SWANSEA BAY TIDAL LAGOON

REVIEW OF ENVIRONMENTAL STATEMENT: SEASCAPE, LANDSCAPE AND VISUAL

Final Report

City and County of Swansea

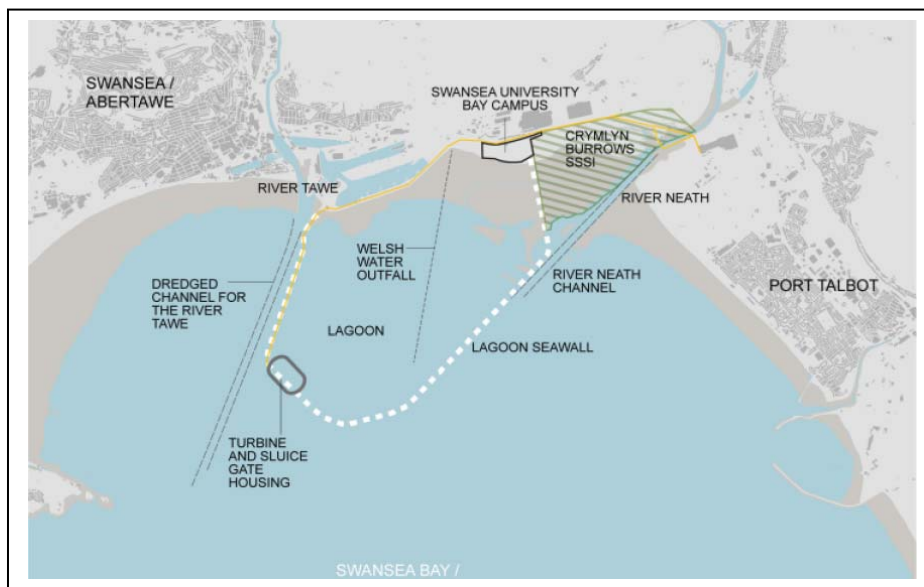
- 2.3. The site lies in Swansea Bay between the mouths of the Tawe and Neath rivers. The landfall of the Lagoon seawall is at Swansea Docks to the east and the Swansea Science and Innovation campus under construction to the west [see Masterplan extract from Figure 1.3 below].
